CITY OF DOVER, DELAWARE
PLANNING COMMISSION
Monday, April 17, 2023 at 7:00 PM

AGENDA

3. S-23-06 College Road Apartments at Railroad Avenue/Grove Street – Continued Review of Site Development Plan for construction of two 6-story mid-rise apartment buildings with a total of 385 units consisting of studio, 1 bedroom, and 2 bedroom units. The ground level of each apartment building is parking and the other site improvements include six 7-car garage buildings, parking lots, landscaping, and recreation areas. The Project also includes street construction/improvements to Raymond Street and Railroad Avenue. A Lot Consolidation Plan will combine the four parcels located east of Railroad Avenue for a total of 31.08 acres of land. These properties are zoned RG-5 (General Residence Zone for Mid-Rise Apartments). The subject area is located north of, but not adjacent to College Road, and east of the Railroad corridor in the vicinity of Raymond Street, Railroad Avenue, and Grove Street. Property Owners: Patel College Properties, LLC and Patel Excess College Road, LLC. Tax Parcels: ED-05-067.00-02-53.00-000, ED-05-067.00-02-54.00-000, ED-05-

CITY OF DOVER PLANNING COMMISSION
MARCH 20, 2023

SHEET 7 OF 10

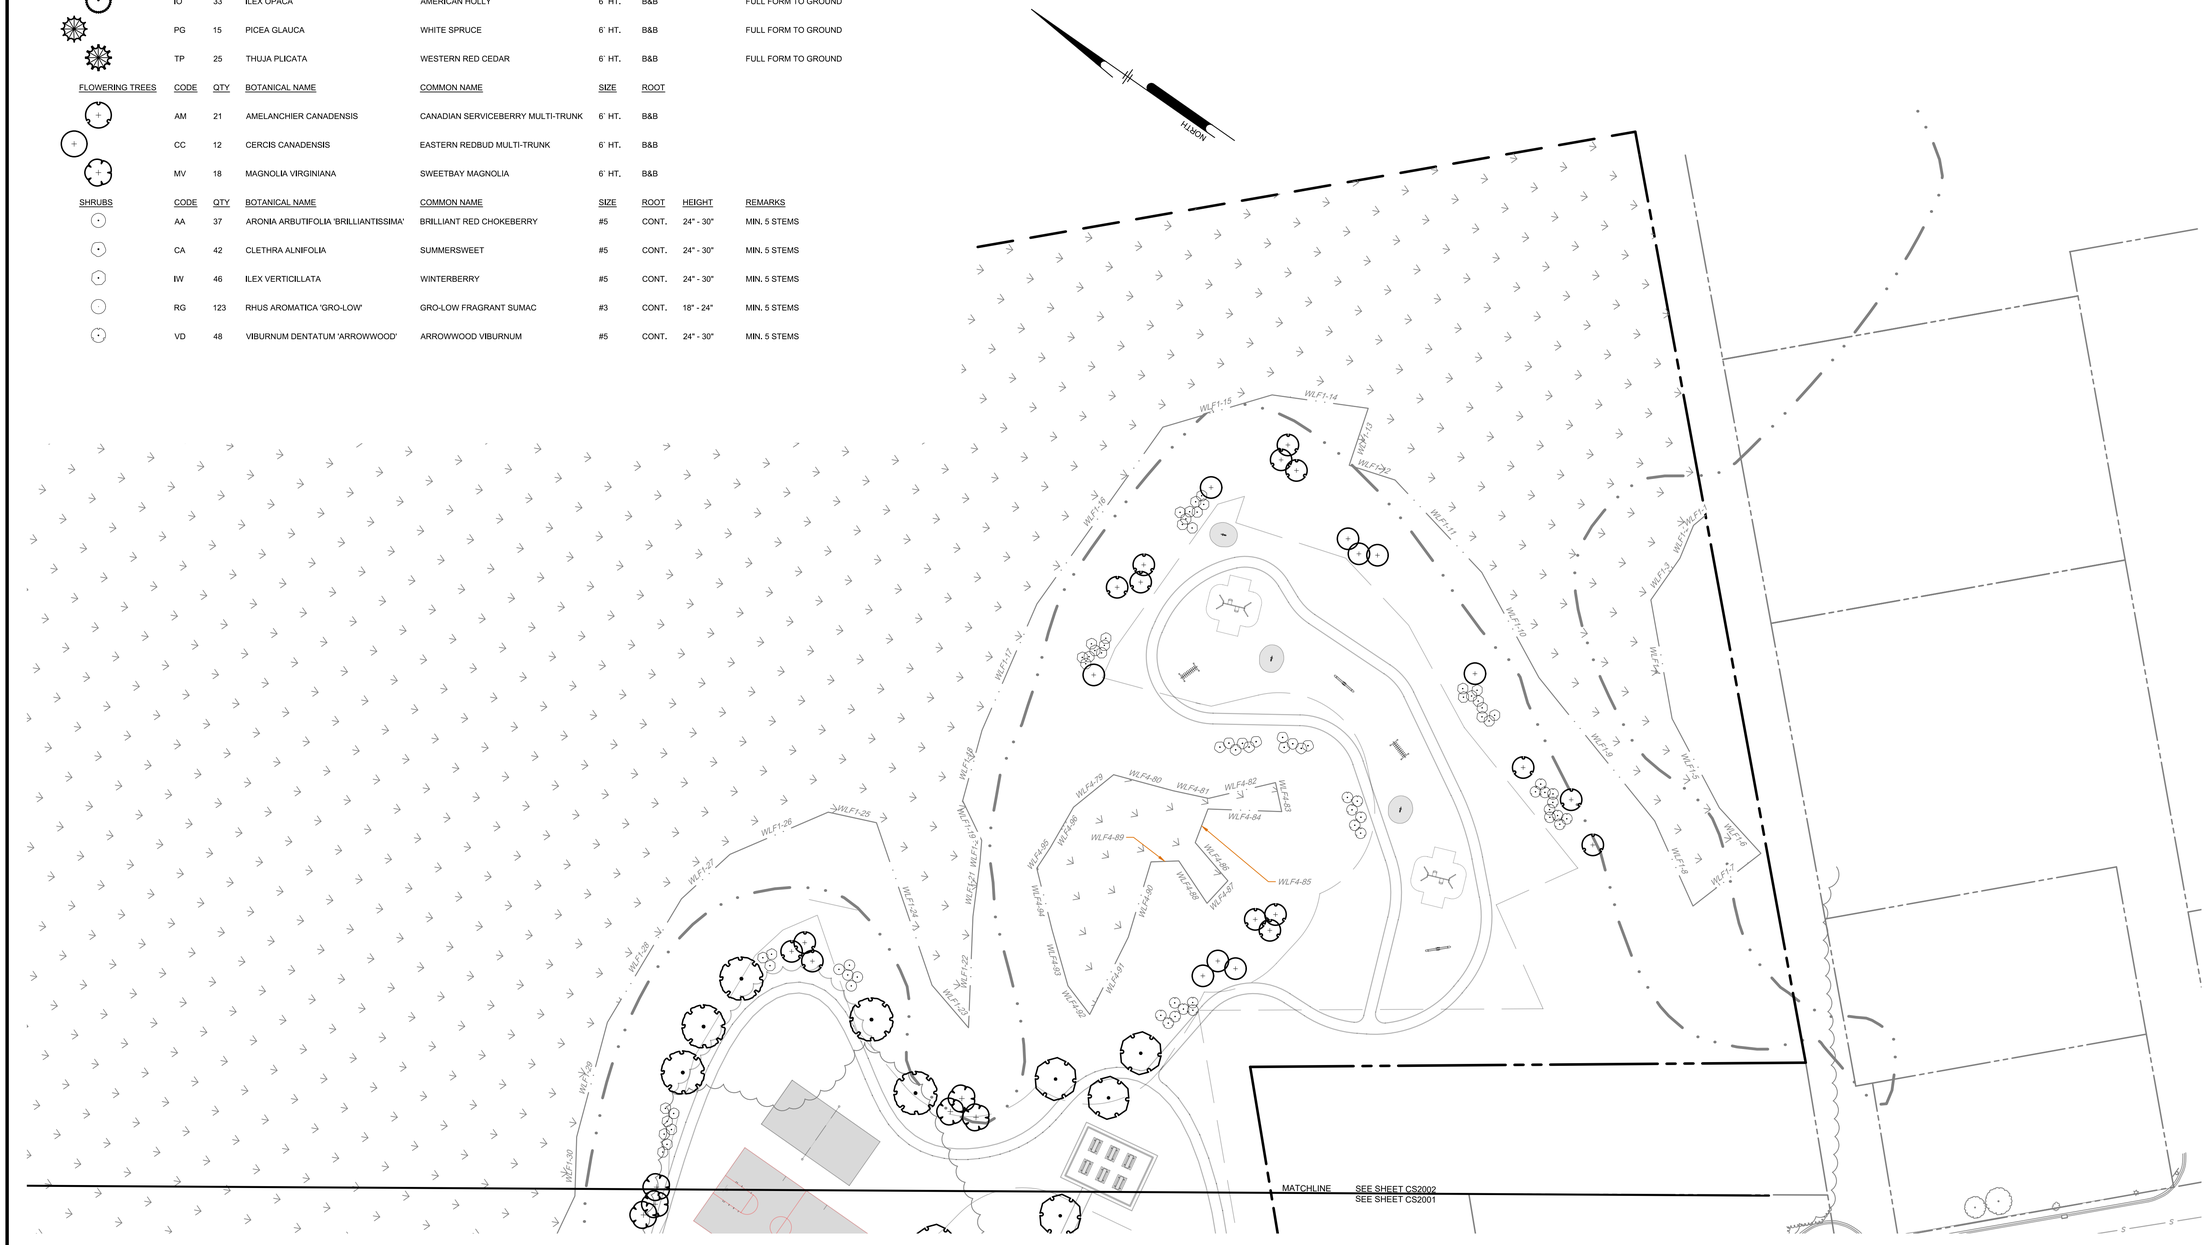
7) Sheets 7 and 8 –Landscape Plan:
   a) Label the tree species on the plan drawings; the use of graphic depictions for each tree specific is difficult to read/review. Also label the shrub plantings for clarity.

SHEET 1 OF 10

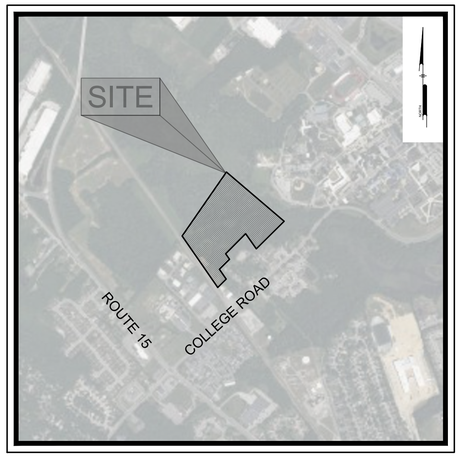
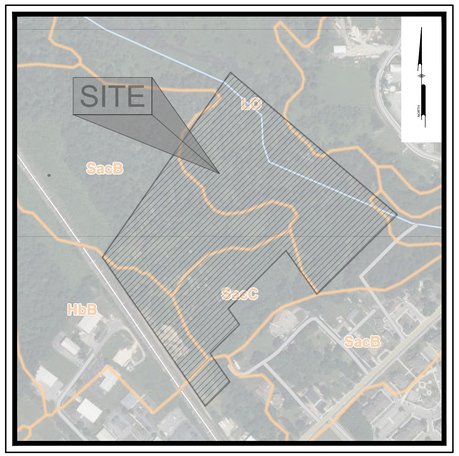
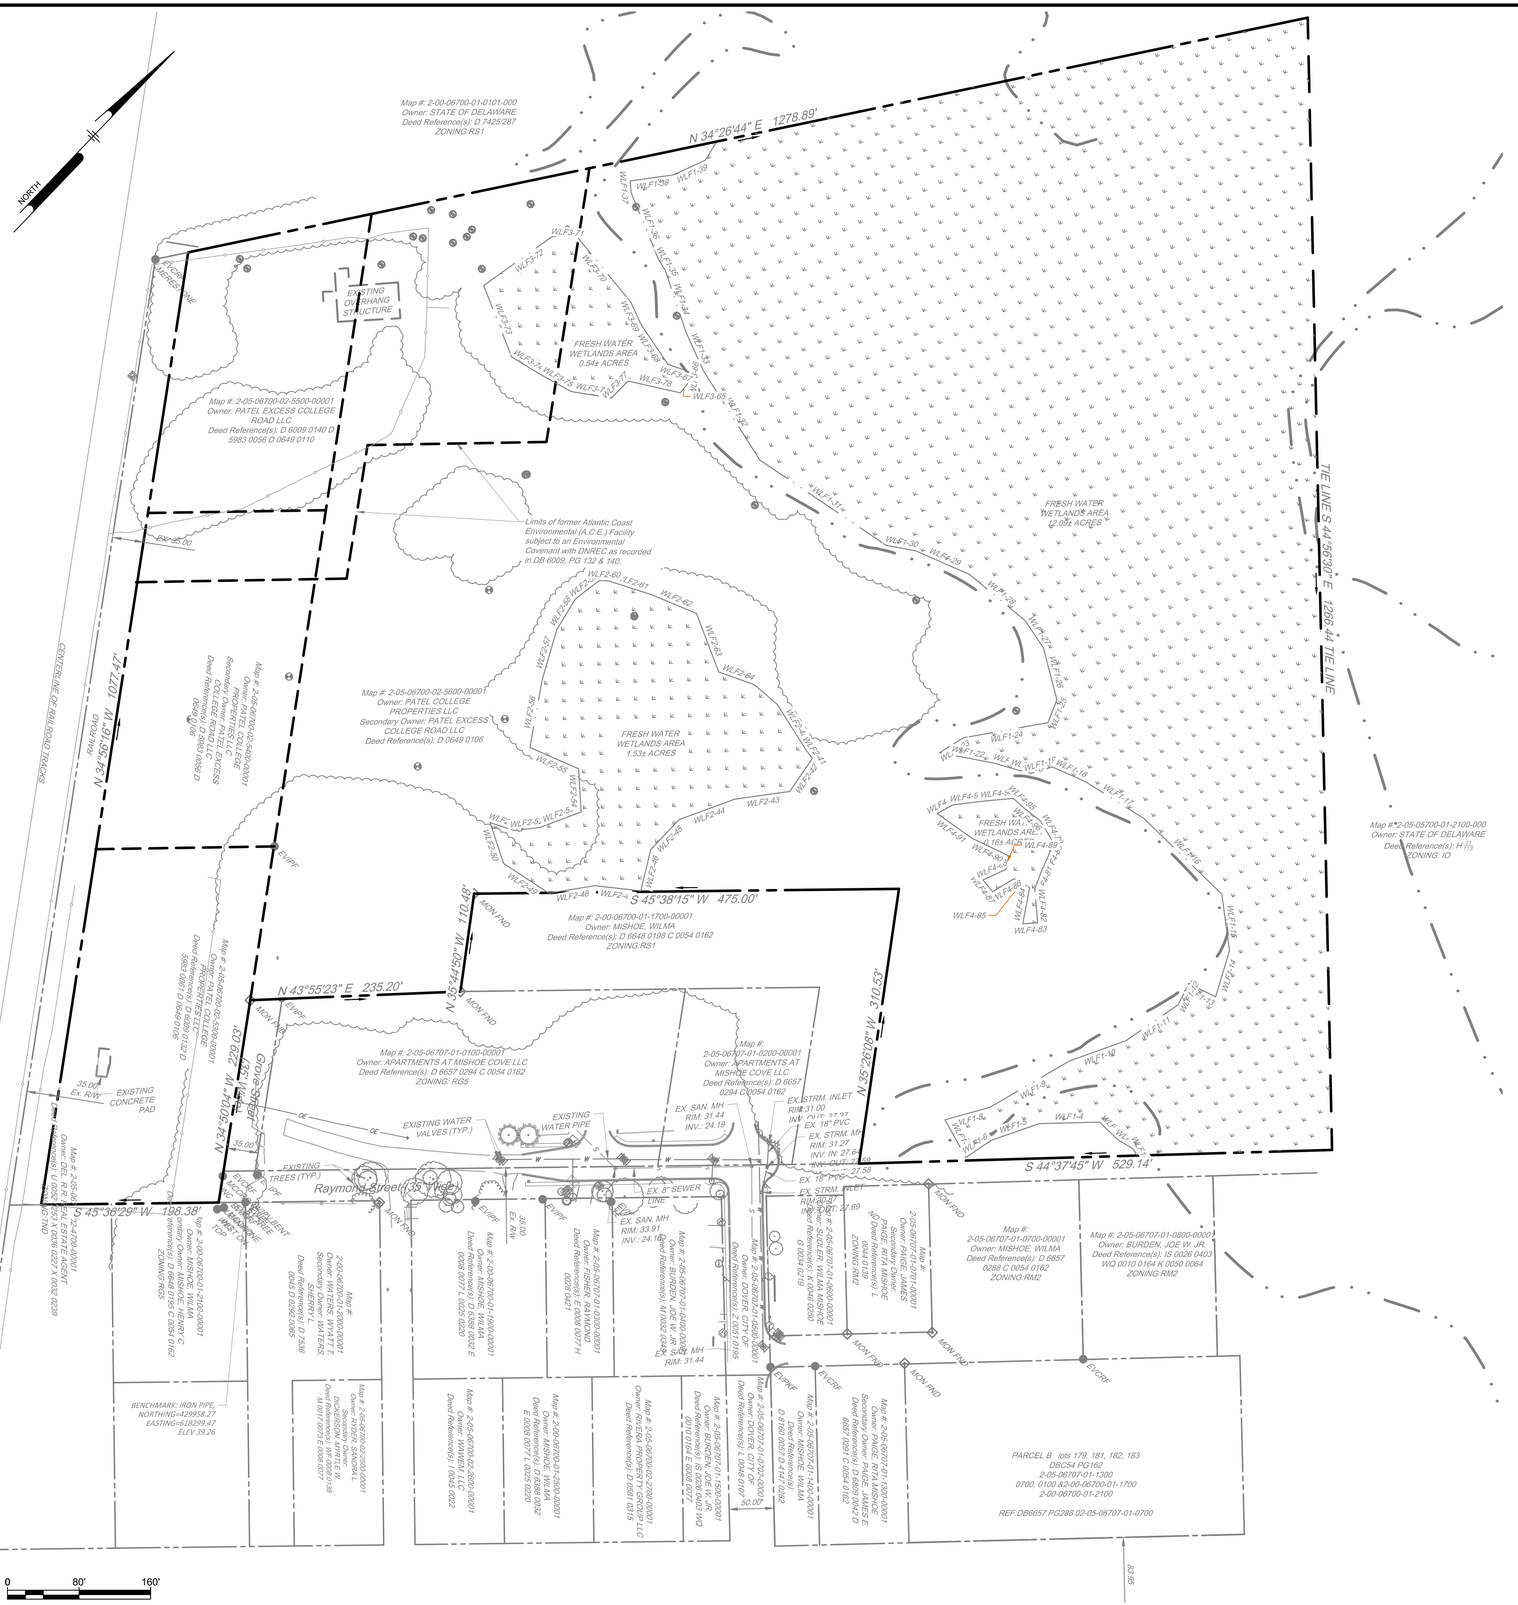
3) Cover Sheet/Sheet 1:
   a) Check spelling in all notes throughout plan set.
   b) The soils map is difficult to read; change soil labeling font style.
   c) List names of signees on behalf of property owners.
   d) Property Summary Column:
      i) Provide complete address of property owners (only street address line is provided).
      ii) List difference between gross and net property area.
      iii) Check survey dates.
   e) Identify any special name for the apartment complex. The has previously reviewed another project referred to as "College Road Apartments."
   f) The Final Plan set will also need to include the Entrance Plan set, Stormwater Management Plan set, and a Record Plan for the Lot Consolidation Plan.

SHEET 3 OF 10

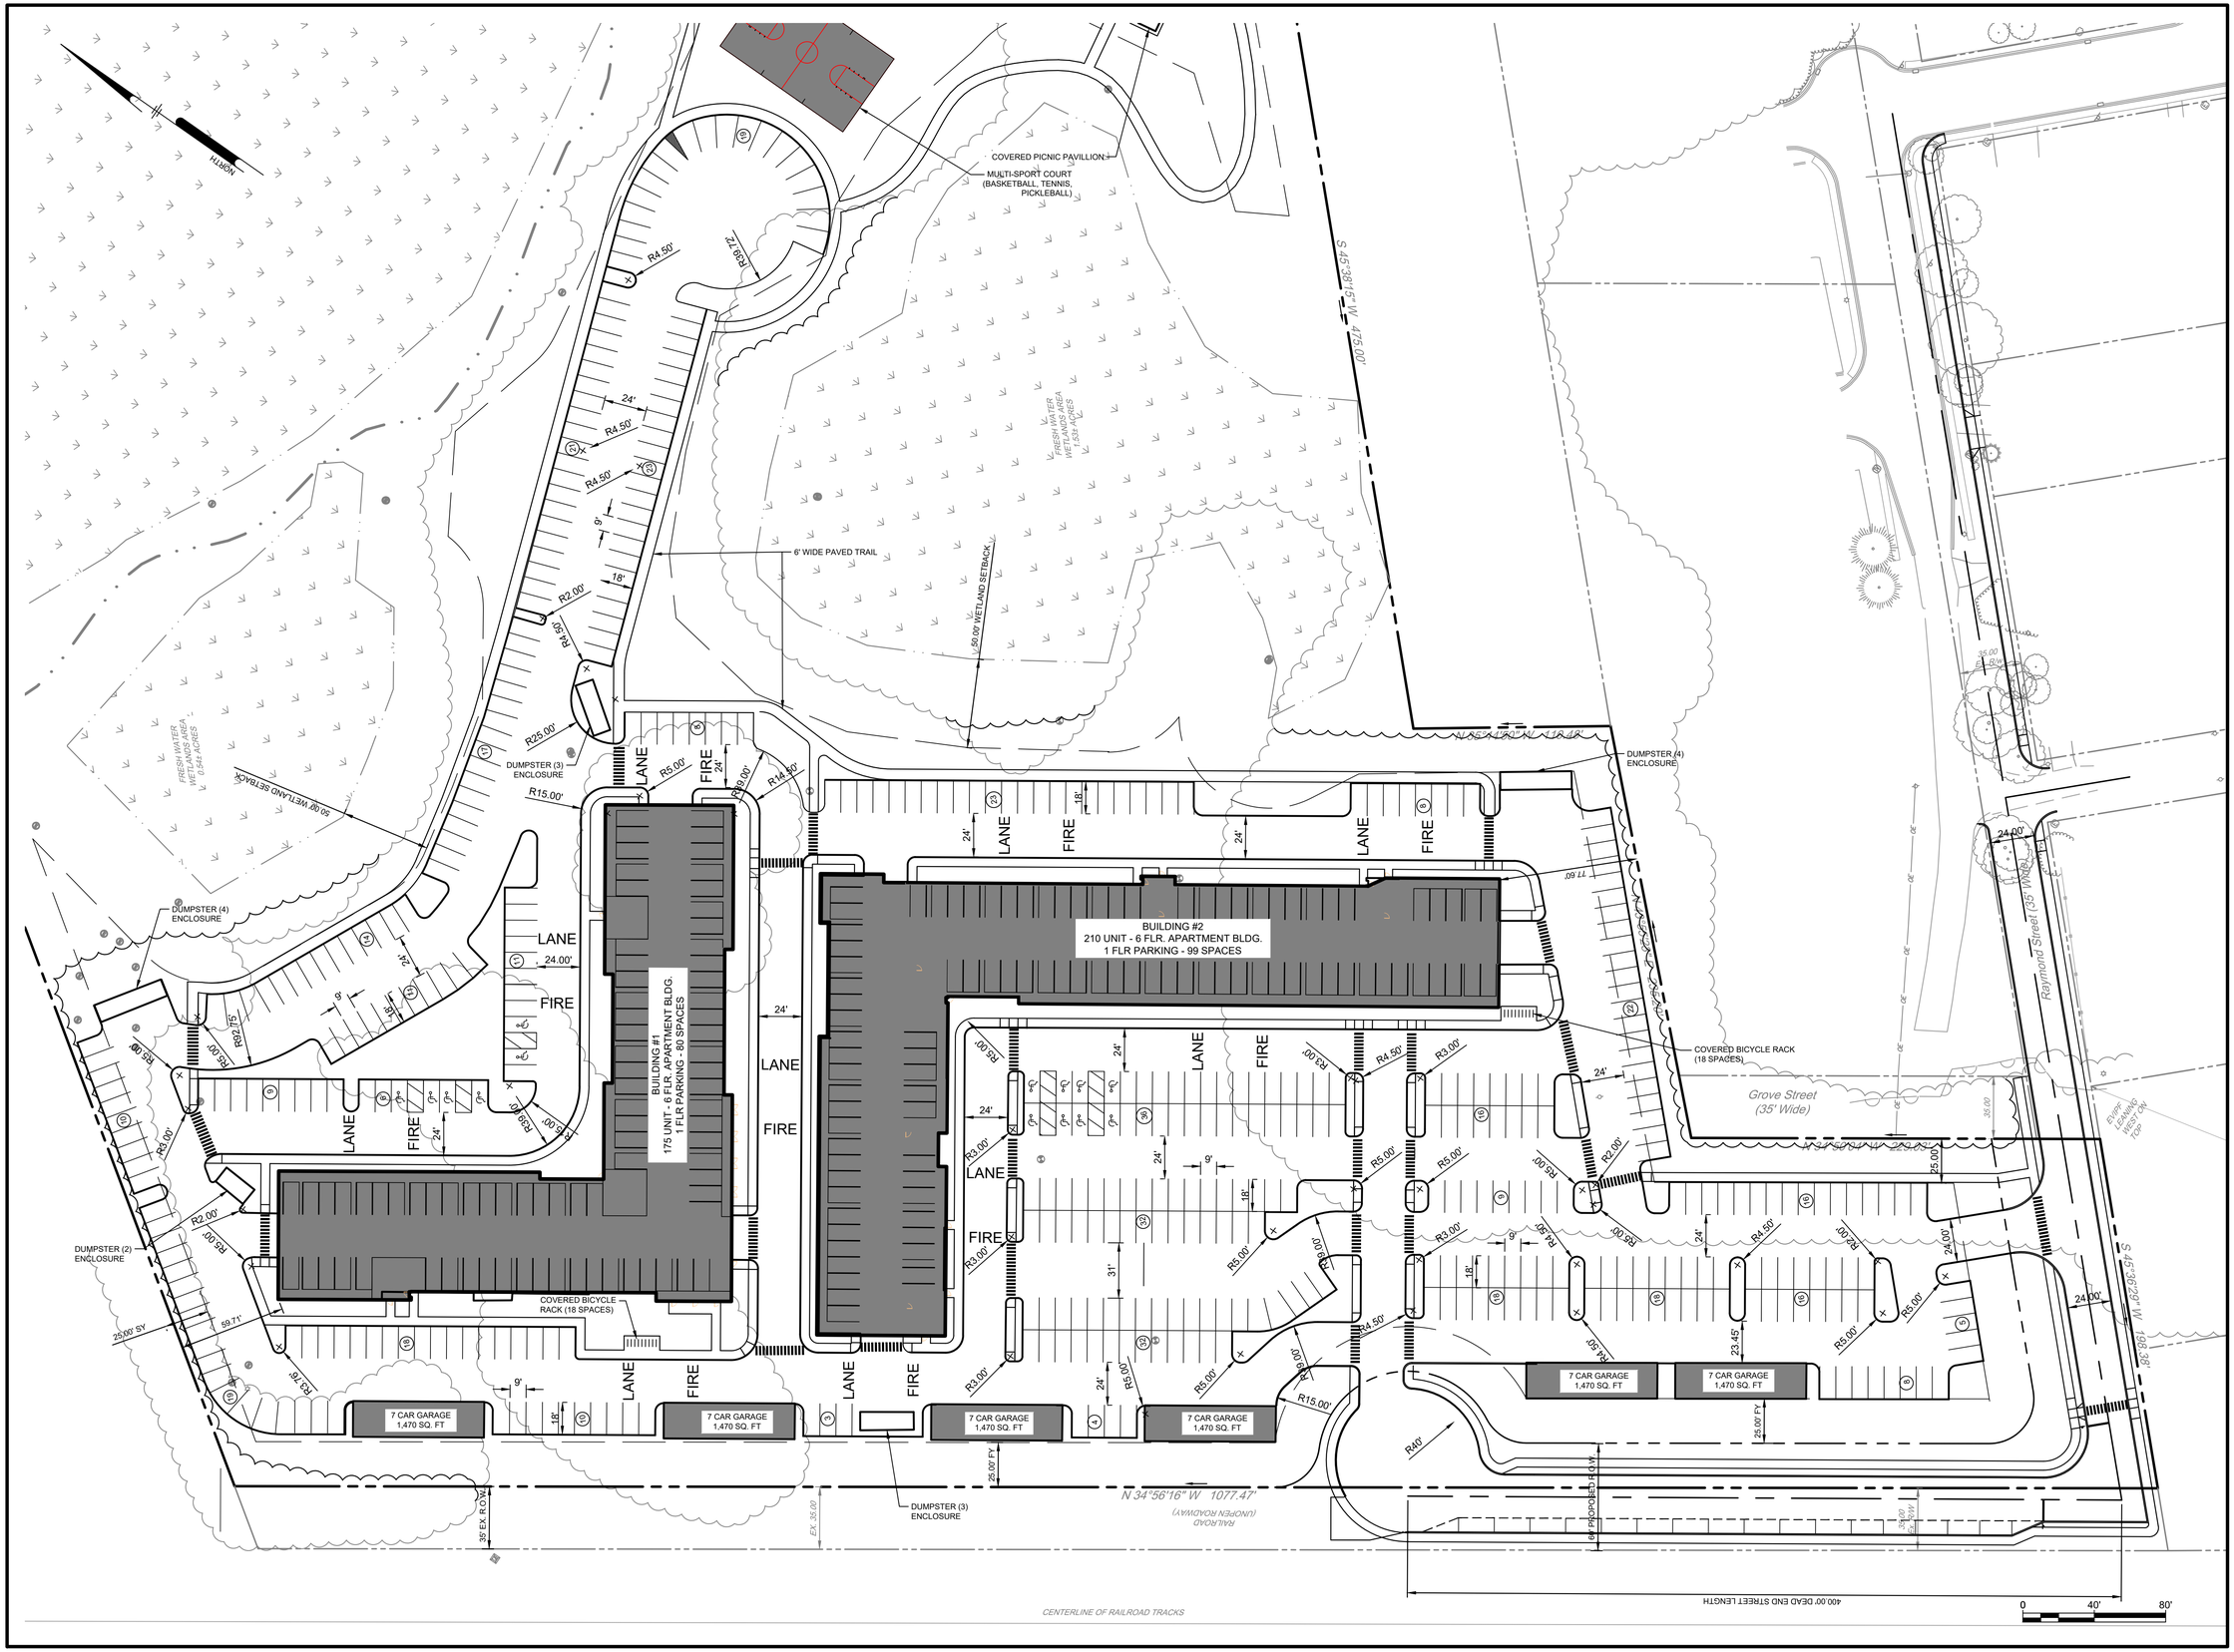
5) Sheet 3 – Overall Site Plan (and also Sheet 4 – Site Plan):
   a) Fire Marshal Notes #3: for the Lock Box (Knox Box) contact the City of Dover Fire Marshal's Office (not Fire Chief).
   b) Clarify the footprints of the small garage units as some linework is missing.
   c) Identify distance of northernmost row of parking to property line.
   d) Data Column listing:
      i) Check listing for missing spaces.
      ii) Clarify what is being considered the gross development area (for recreation area).
      iii) Required number of Dumpsters is 16 units.
   e) Waivers Required Notation: Remove reference to variances. Add action taken on this waiver request.
   f) List floodplain information.
